COMMITTEE OF THE WHOLE JUNE 16, 2003

**BLOCK 57/58 WEST BLOCK PLAN
BLOCK PLAN FILE BL.57/58W.99
HUNTINGTON BUSINESS PARK LAND OWNERS**

Red-Lined Block 57/58 West Plan

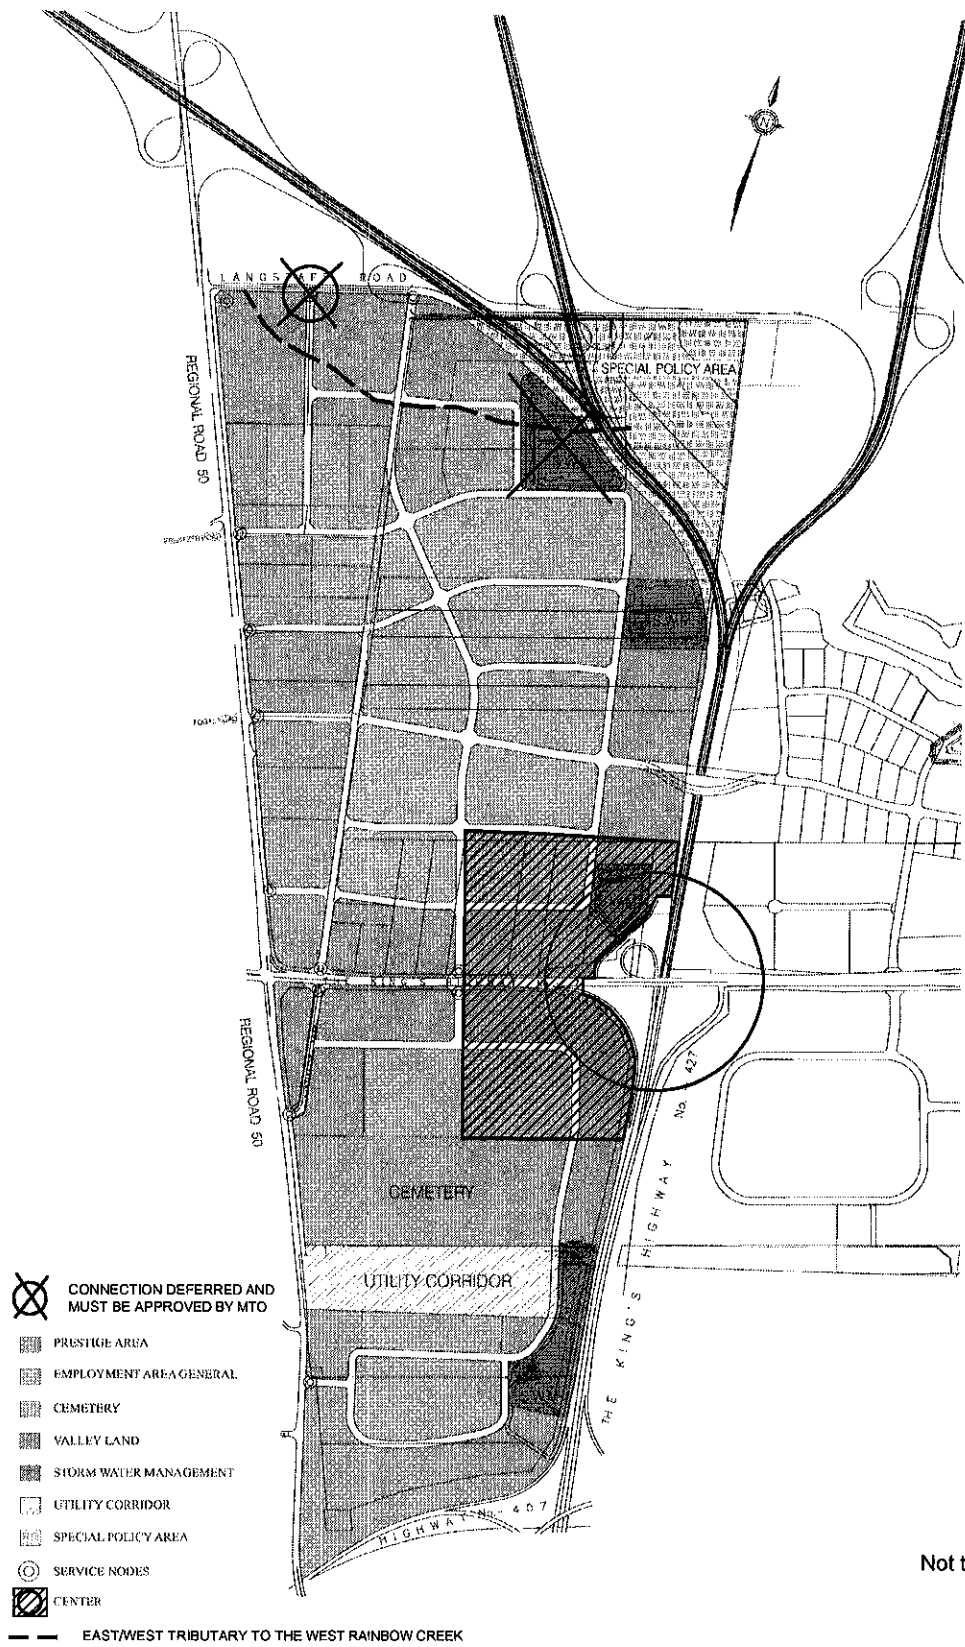
1. THAT the Block 57/58 West Plan (File: BL.57/58W.99) dated May 1, 2003, as red-lined (Attachment # 4), Be Approved subject to the following conditions:

- The extension of the "Centre" area north and south of Hwy. #7as red-lined;
 - That no road connection from the Block to Langstaff Road be permitted until such time as it is decided if there will be an interchange with the Highway 427 extension at Langstaff Road and its ultimate location;

- That the Block Plan be amended to incorporate the east-west tributary to the West Rainbow Creek in an open space block and that Stormwater Management Pond A1 be relocated to the satisfaction of the City of Vaughan Engineering and Planning Departments, and the TRCA; and, that all necessary permits and approvals be obtained from the Department of Fisheries and Oceans, the Ministry of Natural Resources, and/or the TRCA; and,

MTO Proposed Deferral Area

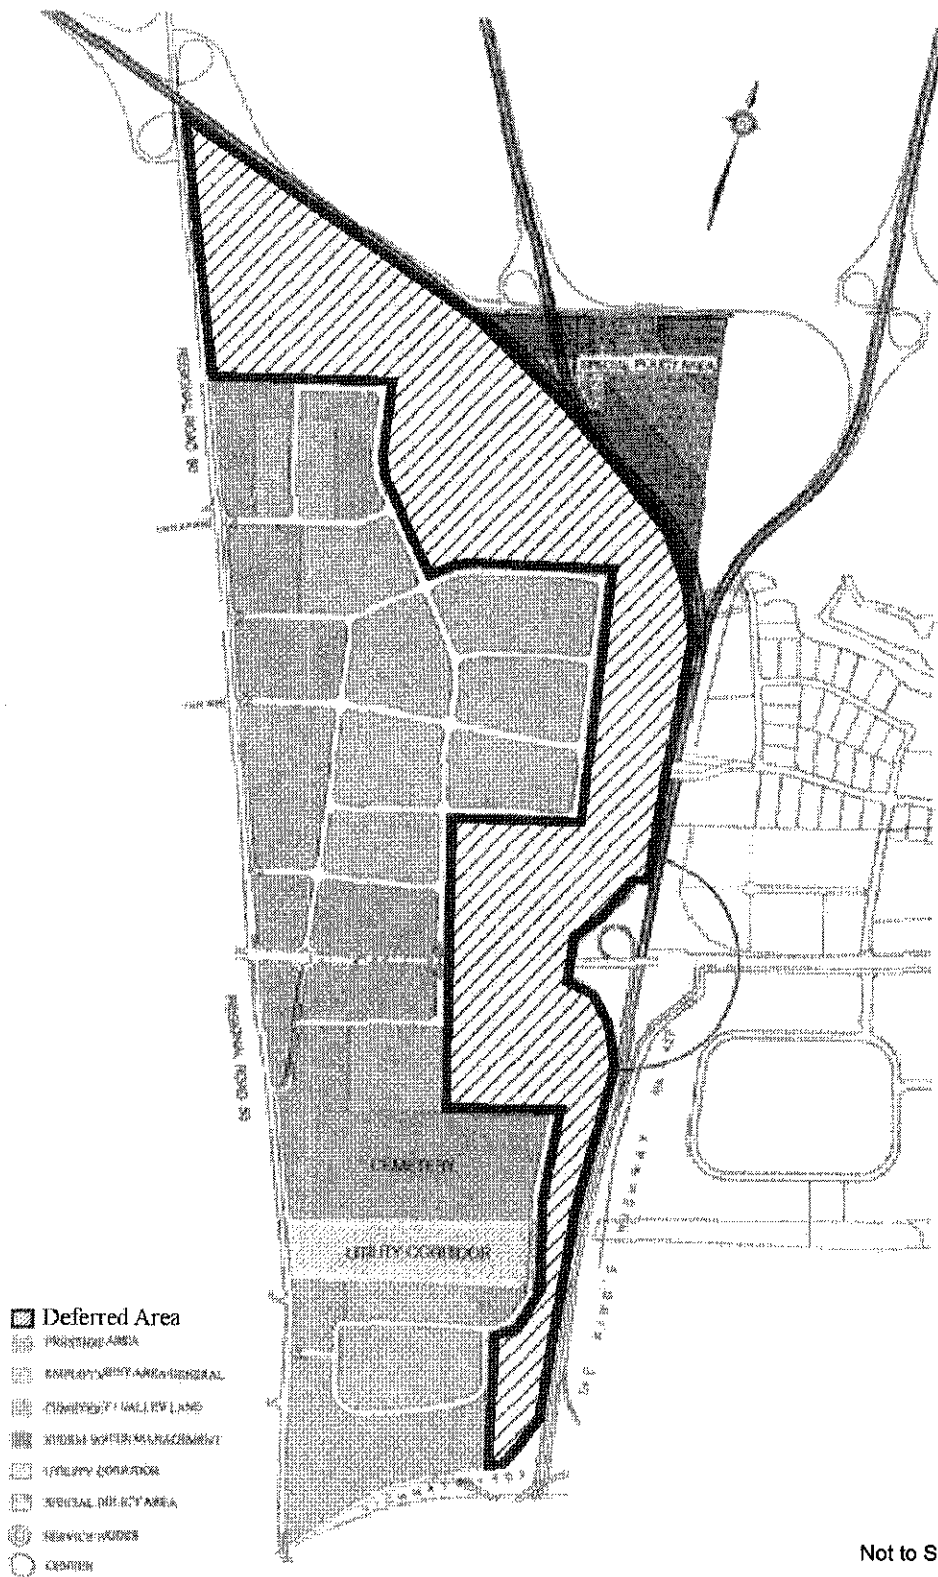
Based on the recommendations of the Panel, the Highway #427 extension has been identified as a potential corridor for future transit initiatives. This corridor is considered to provide an excellent opportunity to link with the proposed Highway 407 transitway. MTO has advised that in addition to the transitway, they are assessing the feasibility of a commuter parking lot and/or transitway station in the area of the Highway 427/Regional Road 7 interchange. To ensure that development within the block plan does not jeopardize these Provincially significant initiatives, MTO has identified a protection area abutting the current Hwy. #427 beyond the "tulip protection area", as shown on Attachment #5.

While the Block Plan can proceed at this time to set out the development pattern for the entire block, this protection area will require separate consideration at the draft plan of subdivision stage. At that time, the protection area can be defined in more detail and the appropriate
